**STAFF RECOMMENDATION**  
**1417 Roberts Avenue**  
**June 19, 2019**

**Application:** Violation—Outbuilding/DADU  
**District:** Eastwood Neighborhood Conservation Zoning Overlay  
**Council District:** 06  
**Base Zoning:** R6  
**Map and Parcel Number:** 08302008100  
**Applicant:** Manuel Zeitlin, Architect  
**Project Lead:** Sean Alexander, sean.alexander@nashville.gov

**Description of Project:** The applicant is requesting to retain and complete the construction of a detached accessory dwelling unit that has deviated from plans approved by the MHZC in May of 2016. As built, the eaves and roof ridge of the outbuilding are taller than the corresponding heights of the house which does not meet the design guidelines nor 17.16.30.G, the DADU ordinance.

1 East Elevation - Original Proposed  
1/8" = 1'-0"

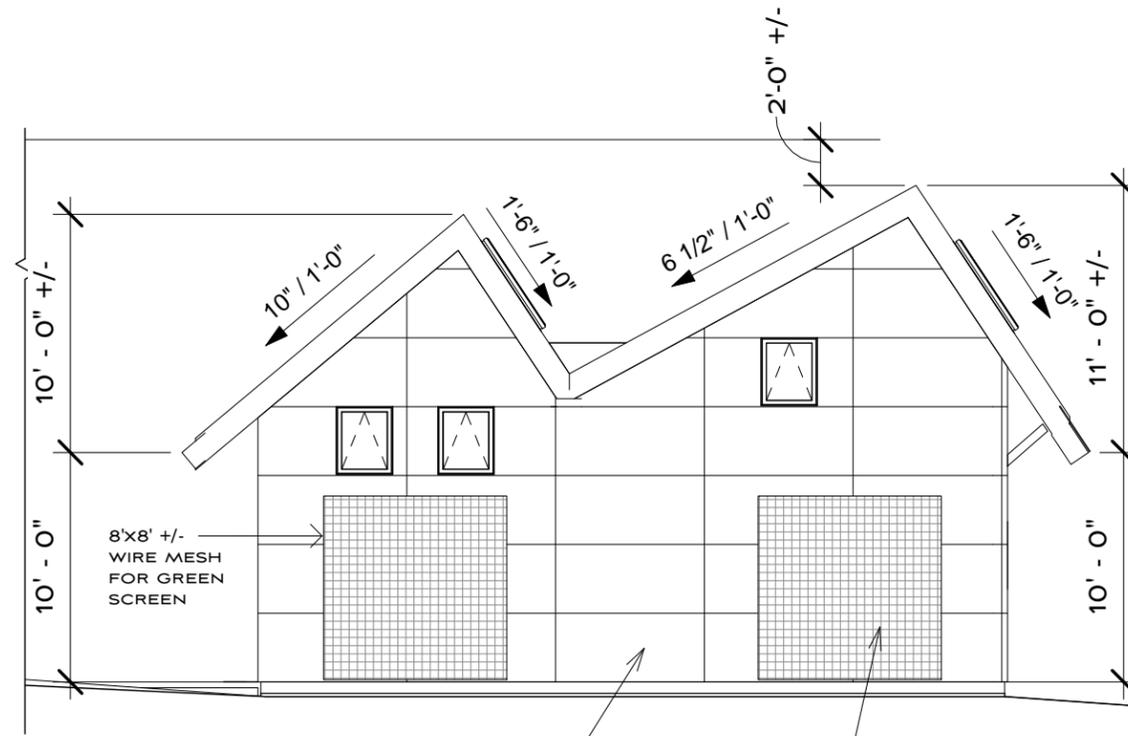
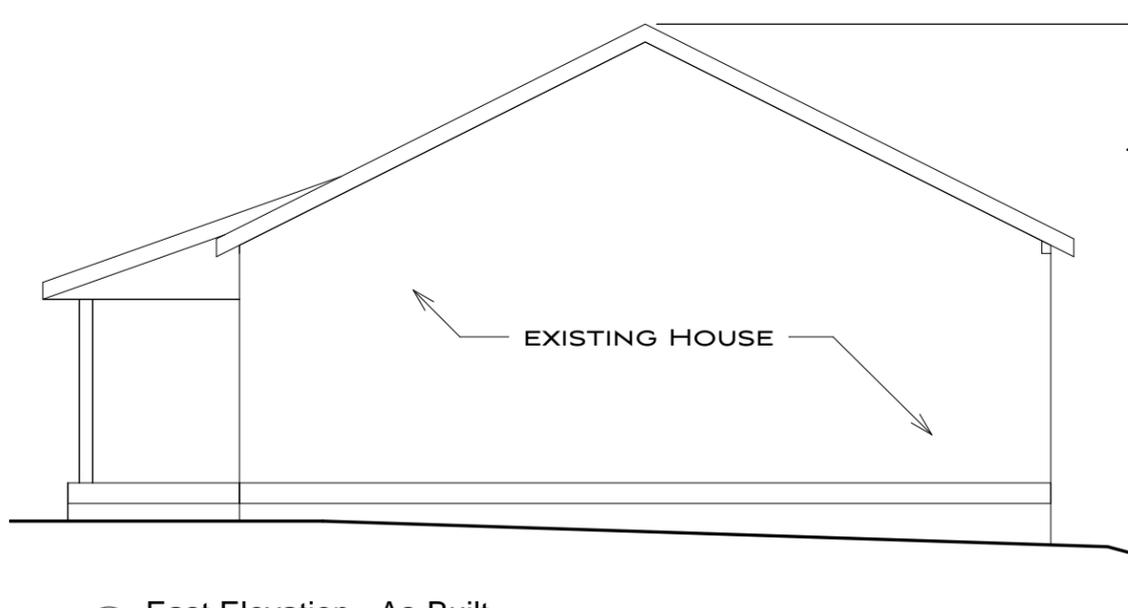
The outbuilding approved in 2016 is currently under construction. During a recent inspection it was discovered that the construction had deviated from the approved plans, with the eaves and roof height taller than the corresponding heights of the house.

The DADU at 1417 Roberts Avenue was approved with an eave height of ten feet (10') and a ridge height of twenty one feet (21'). These heights equal the eave and roof ridge height of the house. The DADU has been constructed with an eave height of thirteen feet, ten inches (13'-10") and a roof ridge height of twenty-three feet, seven inches (23'-7").

As constructed, the outbuilding does not meet Section II.B.2.h of the design guidelines or the standards for bulk and massing of Detached Accessory Dwelling Units in Section 17.16.030.G of the Metro Code.

**Recommendation:** Staff recommends disapproval of the application to retain and complete construction of the outbuilding with eaves and roof ridge height taller than the corresponding heights on the principal building and further recommends that the violation be corrected within sixty (60) days. Staff finds that the outbuilding/DADU, as built, does not meet Section II.B.2.h. of the design guidelines for the Eastwood Neighborhood Conservation Zoning Overlay. It also does not meet 17.16.30.G, the DADU ordinance.
